INTERMOUNTAIN POWER SERVICE CORPORATION

Engineering Test and Inspection Sheet

Equipment Burners Unit # 1 Test/Inspection Date April 15, 1994
 Inspector Garry Christensen, Cecil James Responsible Engineer (Initials) _____

Name: Jim Nelson	Date: May 2, 1994
Company: IPSC	From: Richard J. Monro
Fax No: 801-864-4970	Proposal No.: 940502
Reference: Unit No. 1 Flame Stabilizers	
Transmitting 2 pages (including cover sheet) from Xerox 7032.

PHOTO 3: E4 stabilizer deformation due to overheating.

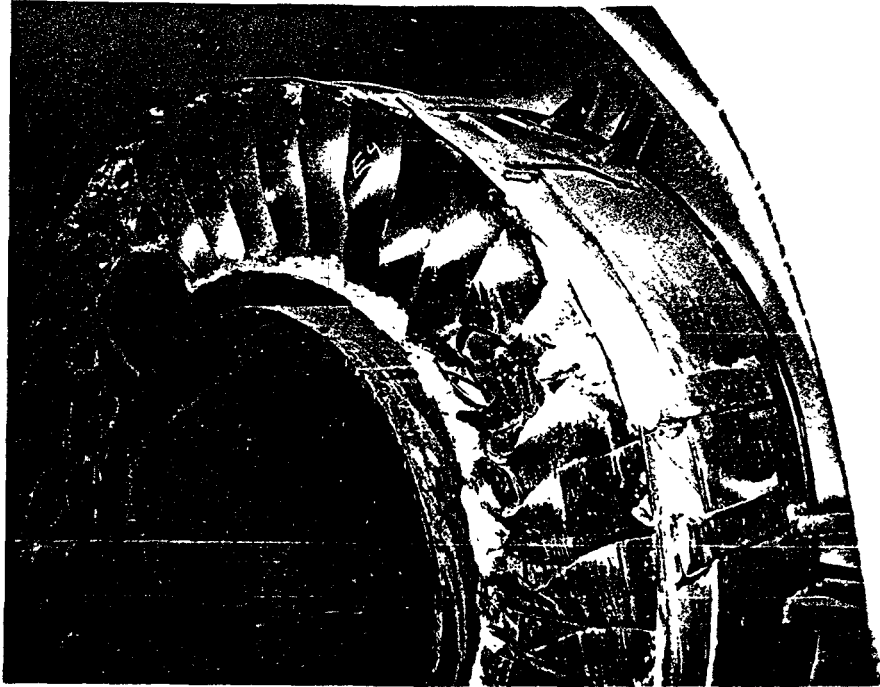
1. Flame Stabilizer Overheating - The distortion and thermal stress patterns on the flame stabilizer along with the ash deposition patterns, indicates the most probable cause of the overheating is due to an over-swirled condition (most likely induced by the outer zone air doors).

Solution - It is recommended that the air doors be set to a more open position. The outer air door position should be opened in small increments and the fires observed to assure that stability is being maintained. (The aerodynamic stability of the flame stabilizer should permit the outer zone air doors to be open to 100% open position while maintaining stable fires. However, proceed in progressive steps to be on the safe side.)

PHOTO 5: Deformation of H2 stabilizer vanes due to overheating.

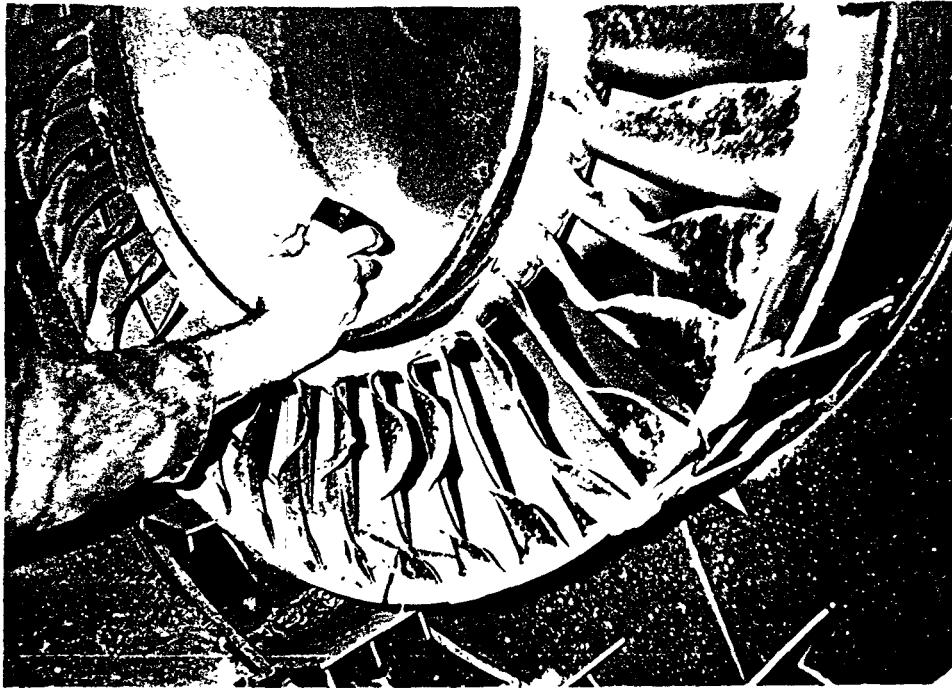
D4, D5, D6	Seized up outer register vanes.	
H2	Stabilizer too deformed for service, PHOTOS 5, 6, 7. Stabilizer replaced.	
H3	Stabilizer too deformed for service, PHOTO 8. Stabilizer replaced. Seized up outer register vanes.	
H4, H5	Nozzle seam weld split approximately 6 inches.	
H6	Stabilizer is starting to blossom.	
C1	Nozzle out of round.	
C2, C5, C6	Seized up outer register vanes.	
C4	Loose outer register shroud. Shrouds reattached with C2: 6-11/16", C5: 6-1/16, C6: 6-1/16" air gaps.	
G2	Stabilizer bowed out at bottom, PHOTO 9. Nozzle has dropped and pushes the stabilizer as it expands.	
G5	The weld between the CS barrel and the SS tip has cracked, PHOTO 10. Nozzle has dropped down onto the stabilizer, PHOTO 11.	
	Nozzle is out of round and resting on stabilizer, PHOTO 12.

PHOTO 8: Crack in the seam weld of the H3 burner nozzle tip.

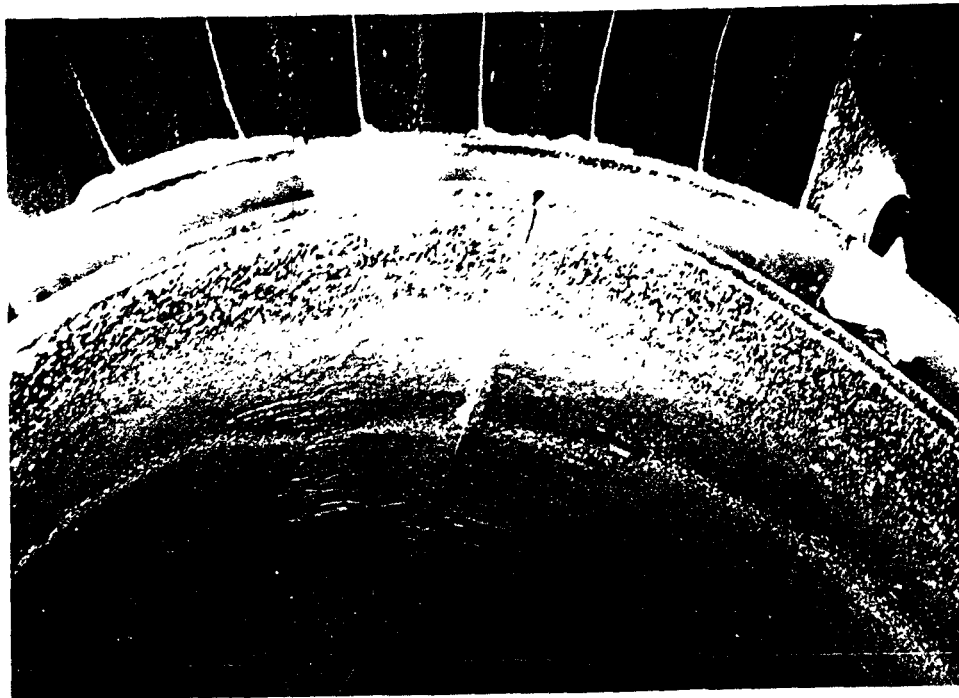
3. Coal Pipe Distortion - All of the photographs show an overheating pattern, and in 60% of the cases a mechanical distortion of the pulverized coal tube in the vicinity of the flame scanner. We suspect this is due to impingement of the igniter flame on the coal tube at this point. This distortion may be setting up circumferential thermal stresses which are forcing the cracking at the welded seam.

Solution - Again, the CFD model can be used to examine the impact pattern of the igniter flame envelope on the pulverized coal tube. The model could then be used to explore various solutions.
